VIRGINIA ELECTRIC AND POWER COMPANY (DOMINION)
NORTH ANNA POWER STATION UNITS 1 AND 2
PROPOSED IMPROVED TECHNICAL SPECIFICATIONS
REQUEST FOR ADDITIONAL INFORMATION (RAI)
SECTION 3.6 (TAC NOS. MB0799 AND MB0800)
MISCELLANEOUS DOMINION CHANGES TO ITS SUBMITTAL

**Proposed Improved Technical Specifications
Responses to Requests for Additional Information
ITS 3.6, "Containment Systems"**

North Anna Power Station Units 1 and 2

Figure 3.4.3-1 (page 1 of 1)
 Unit 1 RCS Heatup Limitations
 Heatup Rates up to 60°F/hr, Applicable for the first 32.3 EFPY,
 Including Margins for Instrumentation Errors

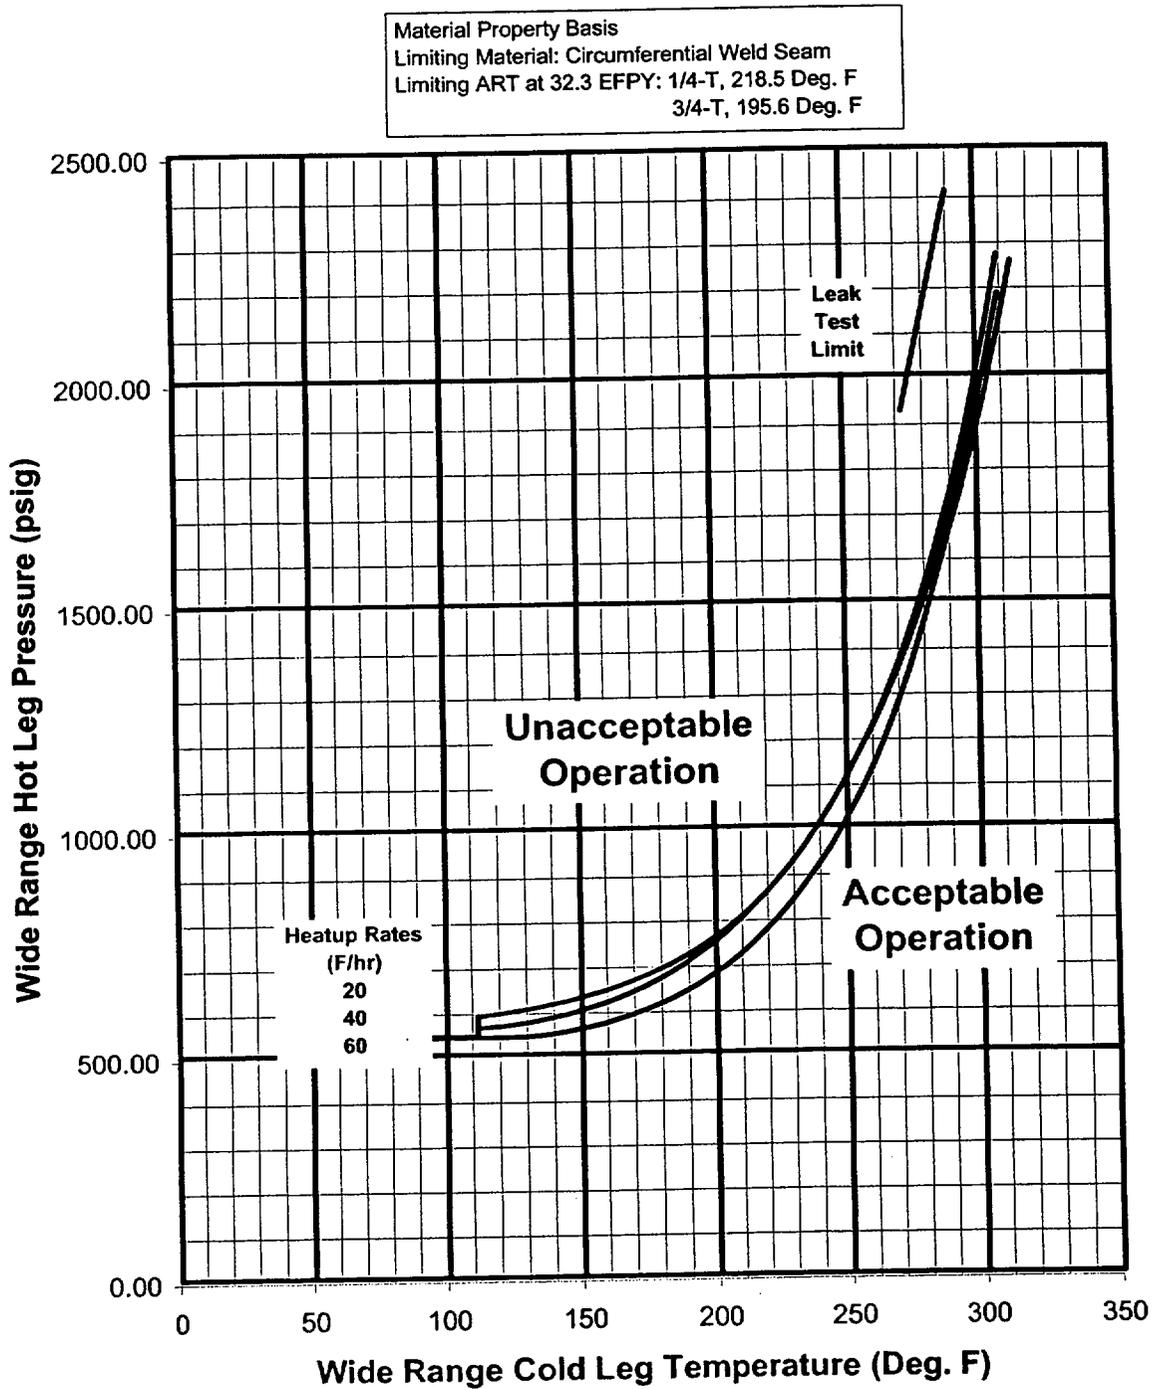
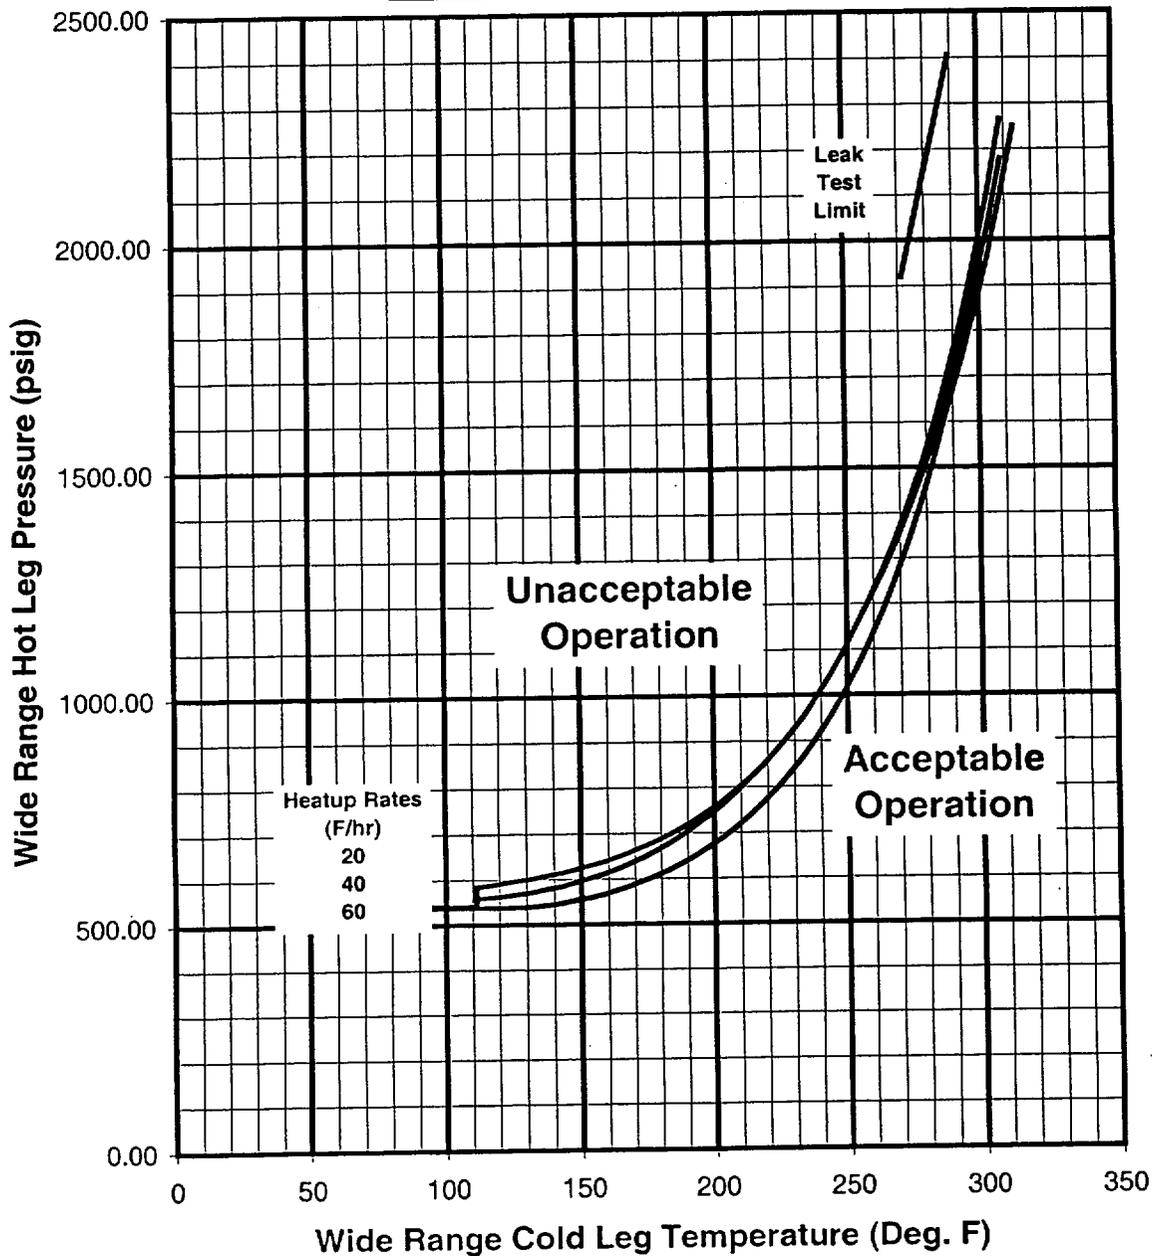
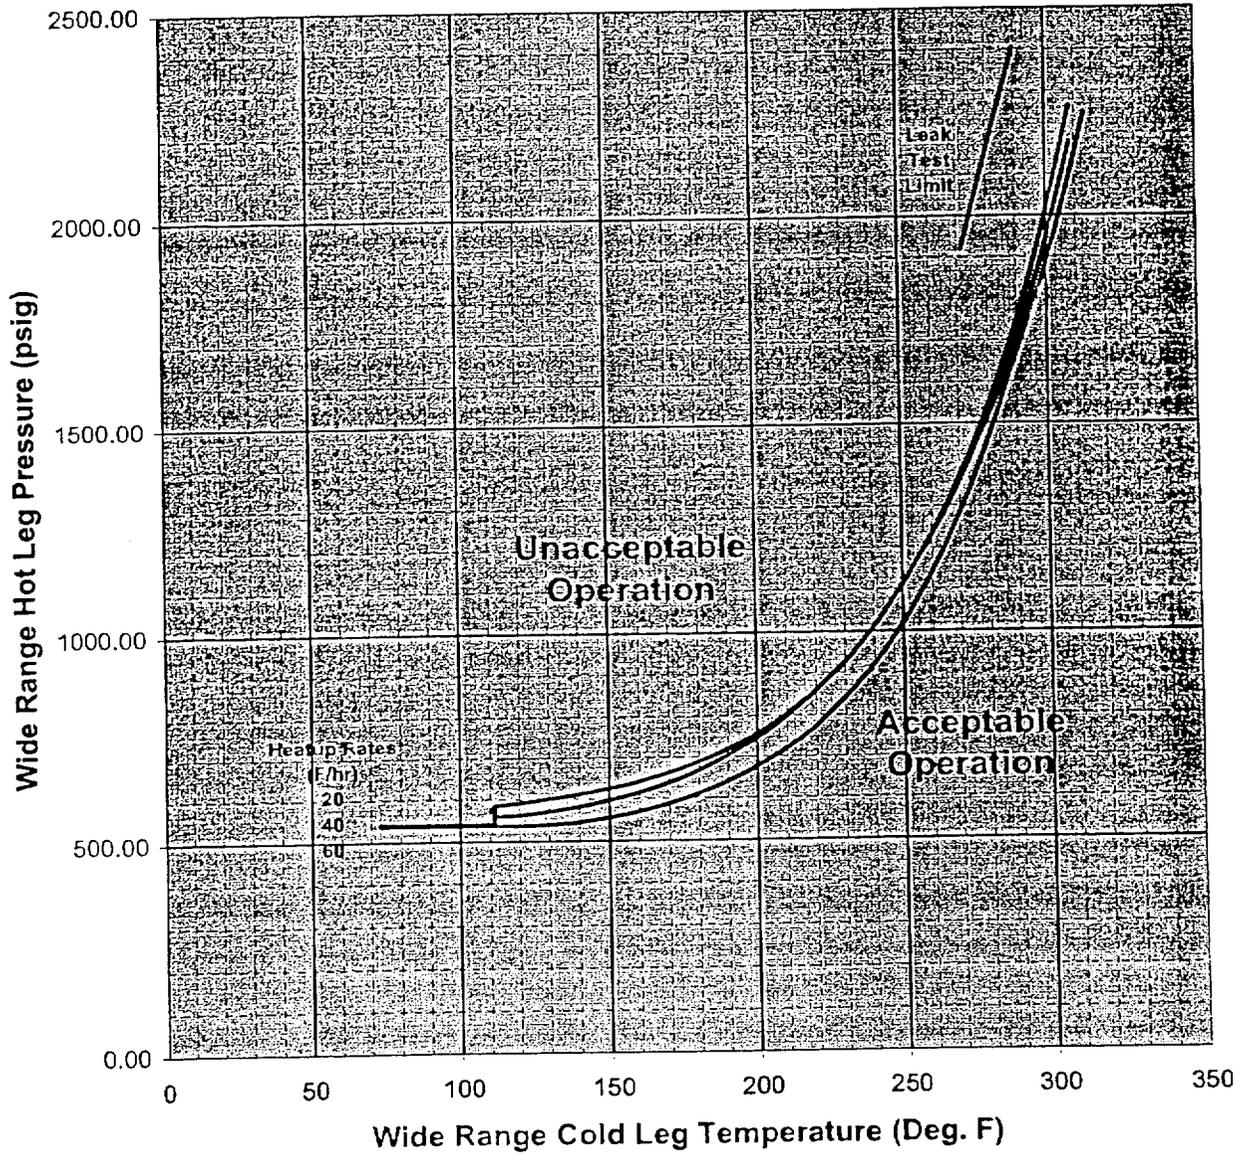
North Anna license amendment 226 (Unit 1) and 207 (Unit 2), dated May 2, 2001, revised the Unit 1 and Unit 2 heatup and cooldown curves. The revised curves are incorporated into the typed ITS, the ISTS markup, and the CTS markup.
